Oncor West Texas 345-kV Infrastructure Rebuild Project – ERCOT Independent Review Update

RPG Meeting April 9, 2024

Appendix – Preferred Upgrade

MAP – Preferred Upgrades

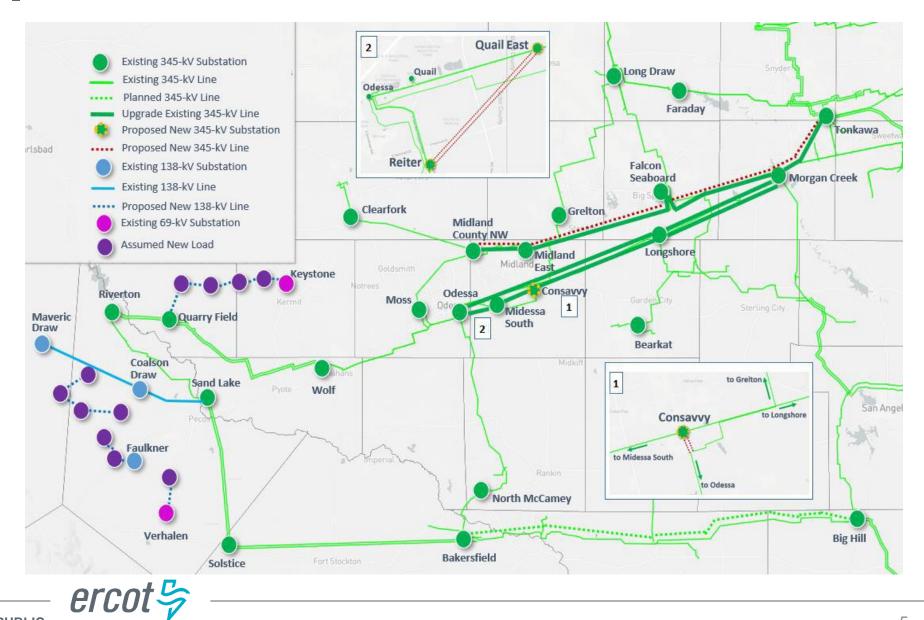
- ERCOT recommends the addition of the West Texas 345-kV Infrastructure Rebuild Project (WTIP) based on the review of the Permian Basin Load Interconnection Study completed December 2021, and the results from the additional studies
